**Rezoning and subdivision for special residential  
development, Lot 401, La Perouse Court,  
Frenchman Bay**

**L'Oire Nominees**

**Report and recommendations  
of the Environmental Protection Authority**

**Environmental Protection Authority  
Perth, Western Australia  
Bulletin 672  
January 1993**

Figure 2: Plan of subdivision (from Alan Tingay & Associates, CER)

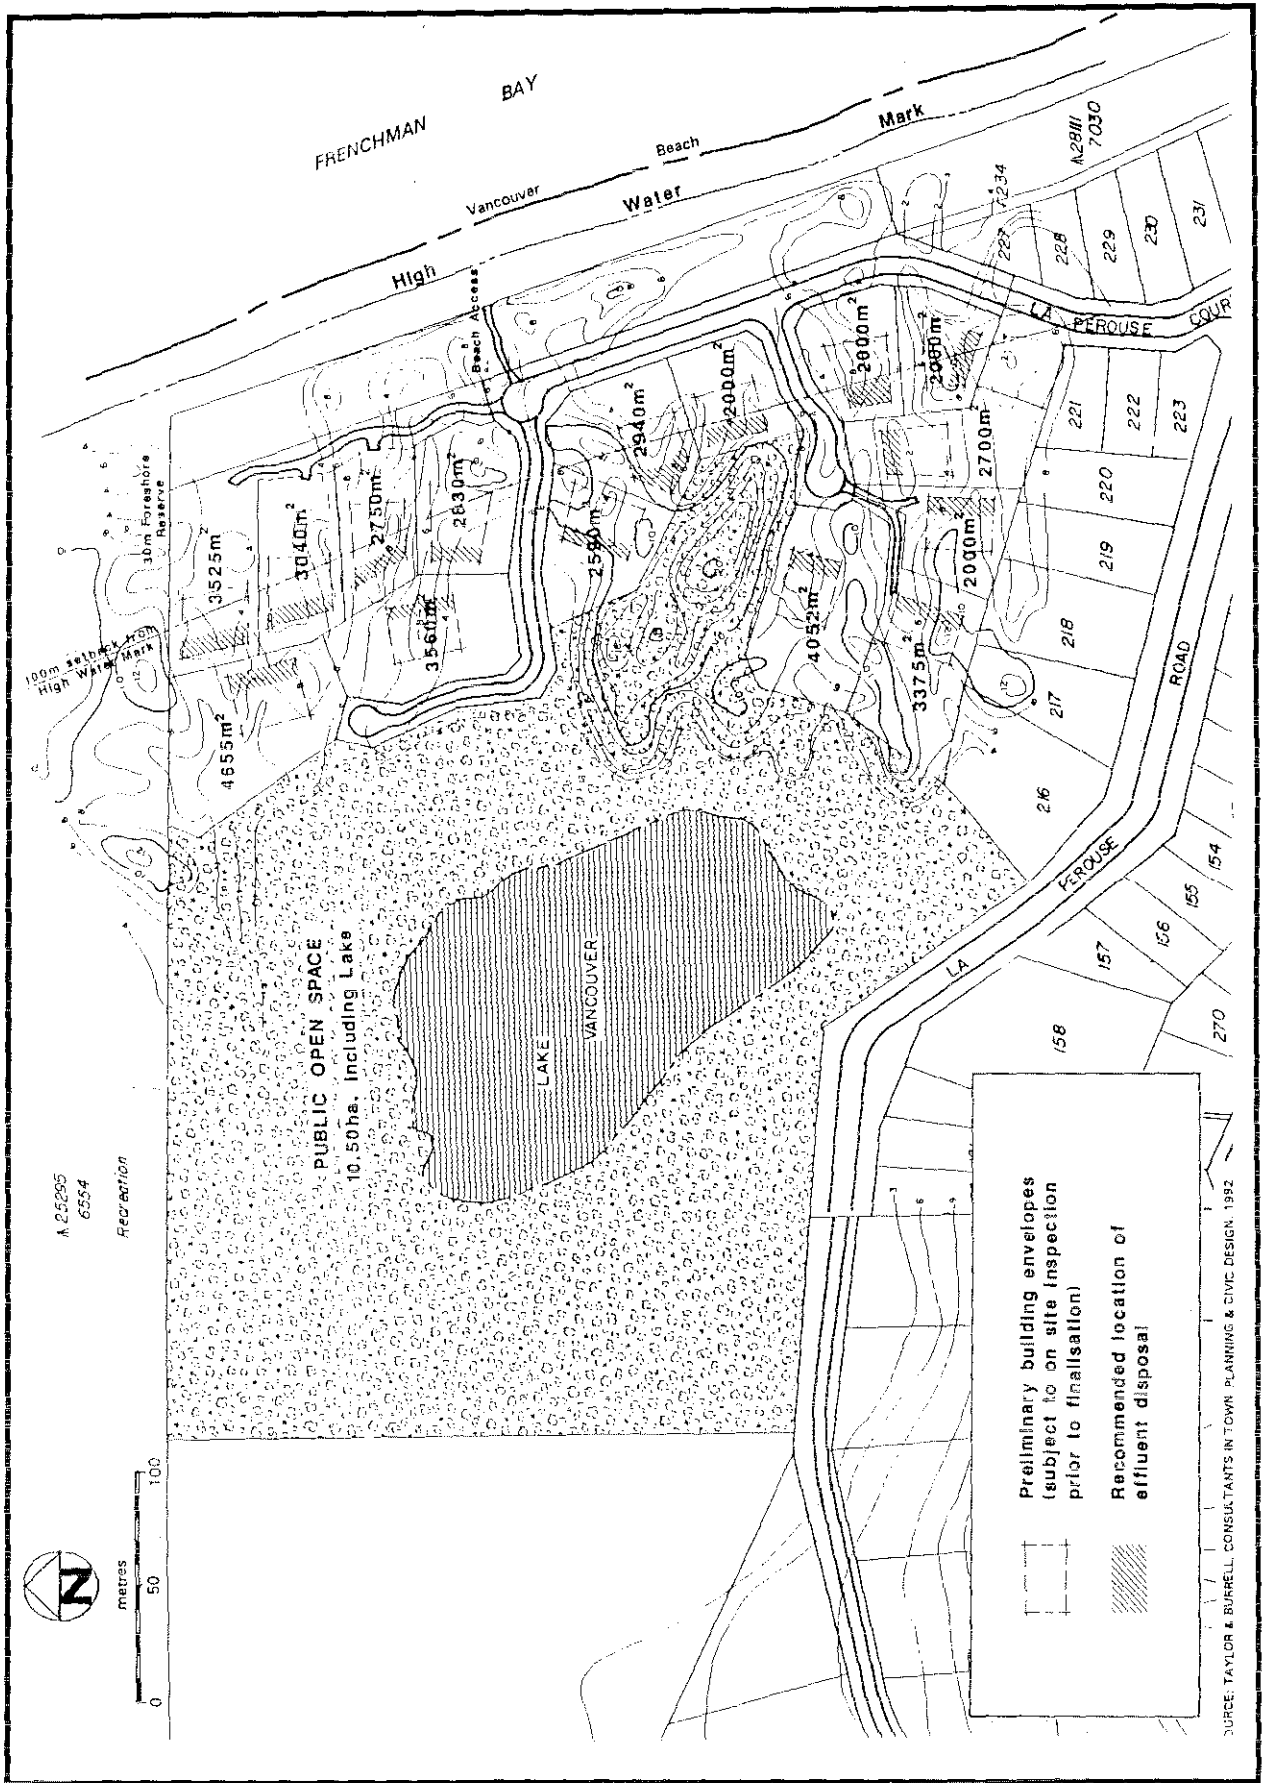
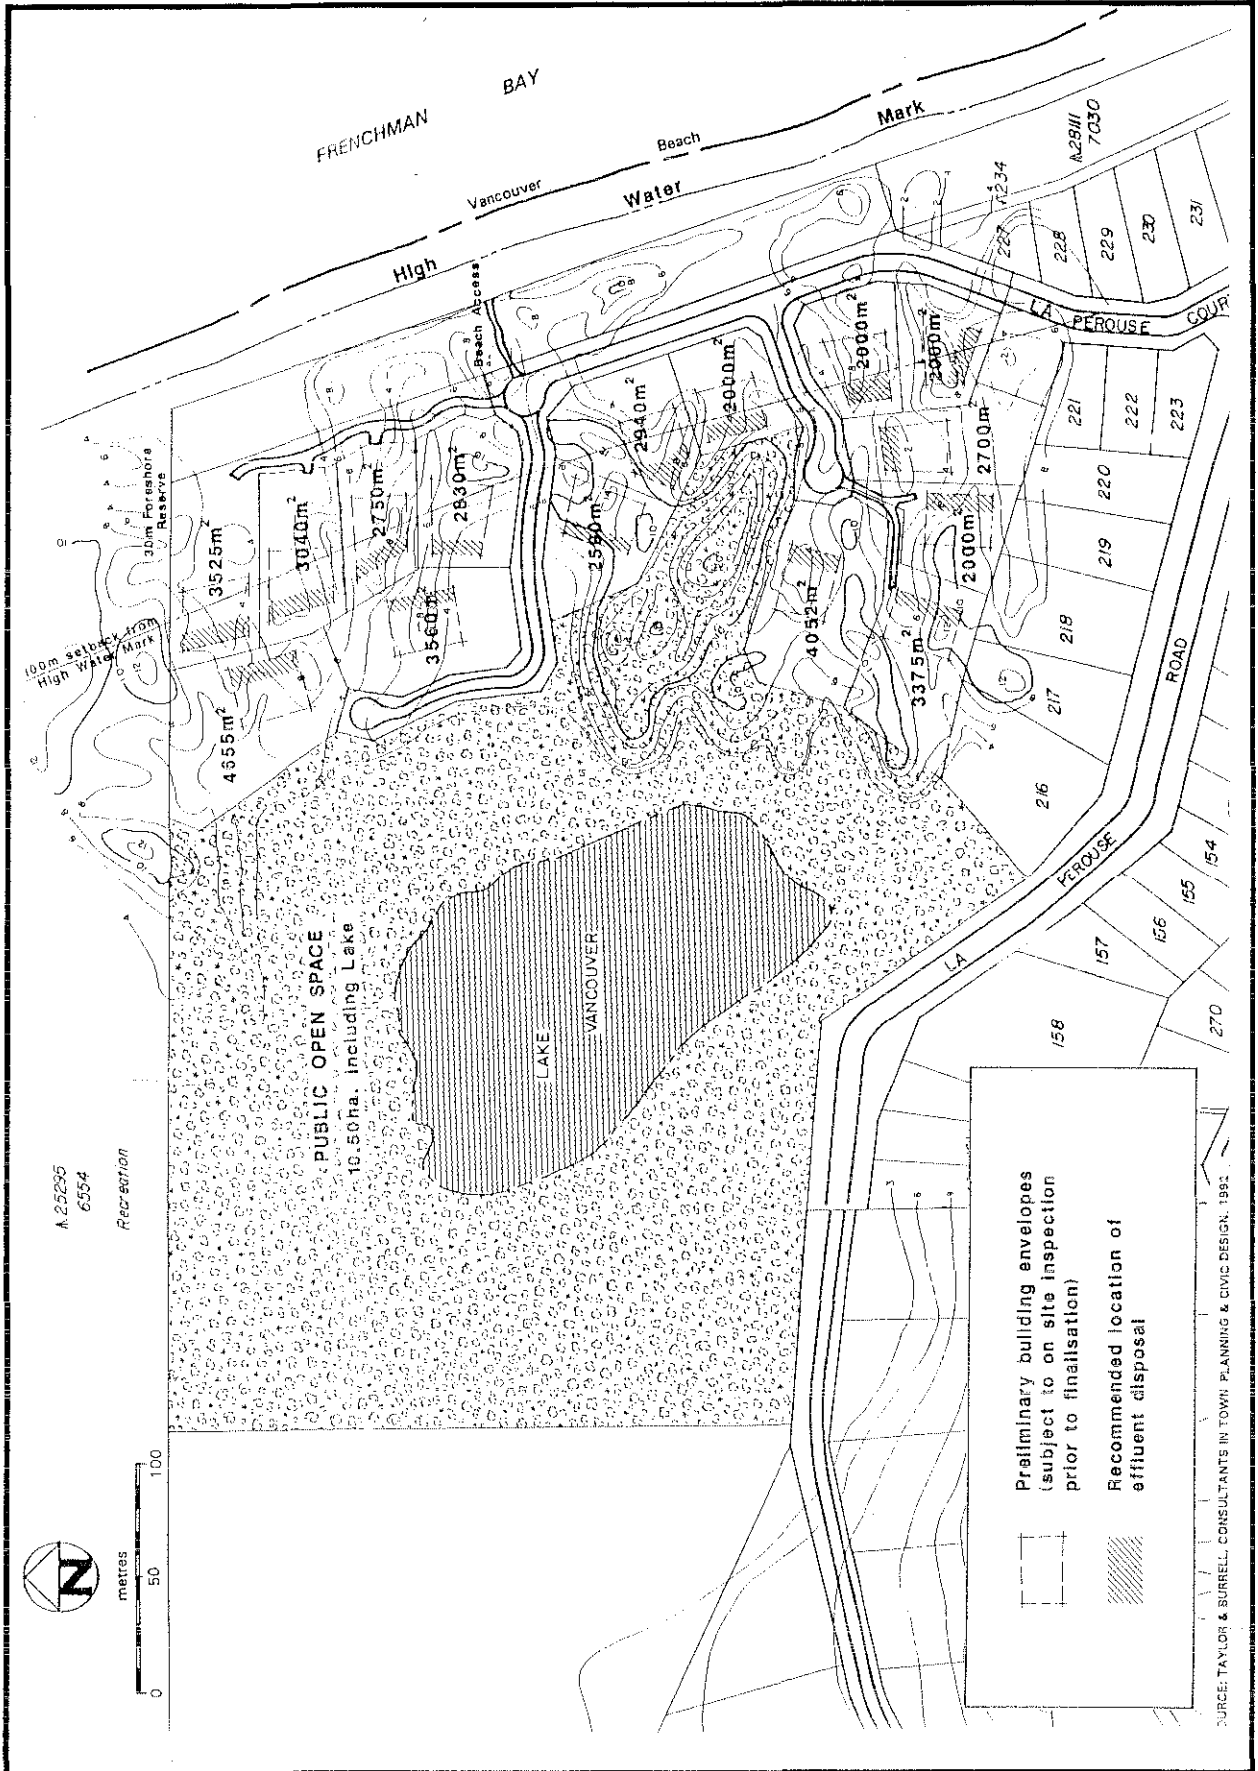
The proposal to set aside 65% of Lot 401 including Vancouver Lake, its margins and all of Lot 401 to the west of lake Vancouver in Public Open Space as described in the Consultative Environmental Review and indicated in Figure 2 of this report, meets the requirements of the Authority and is environmentally acceptable. The Environmental Protection Authority has included a recommendation in regard to Lake Vancouver which reflects the proponents intentions and the public submissions.

- 2.1 set aside Lake Vancouver and its margins and all of Lot 401 to the west of Lake Vancouver as indicated in Figure 2 for conservation, to meet the requirements of the State Planning Commission on advice from the Environmental Protection Authority and the Shire of Albany;

- 2.1 set aside Lake Vancouver and its margins and all of Lot 401 to the west of Lake Vancouver as indicated in Figure 2 for conservation, to meet the requirements of the State Planning Commission on advice from the Environmental Protection Authority and the Shire of Albany;
